Product Change Notification

Change Notification #: 113975 - 00
Change Title: Intel® Dual Band Wireless-AC 8260,
Product Codes: 8260.D2WMLG,
8260.D2WMLG.NV, 8260.D2WMLG.S ,
PCN 113975-00, Product Design, Label
OTP Update
Date of Publication: July 16, 2015

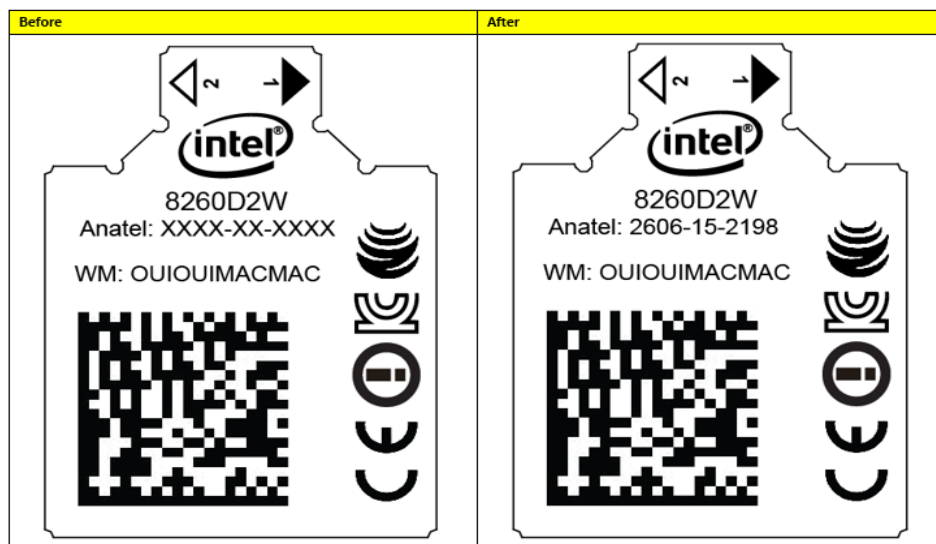
The Intel® Dual Band Wireless-AC 8260 (Snowfield Peak) module will have 2 changes.

1. An internal review of the Snowfield Peak (SfP) OTP power table showed that the 11ac power setting on channel 58 can marginally exceed the FCC band edge limits. Intel is taking immediate action to reduce the power on channel 58 to ensure SfP is within regulatory band edge limits.

2. Add Brazil Anatel ID to laser mark.

Minor change to power setting for AC Channel 58 and Addition of Brazil regulatory marking on label.
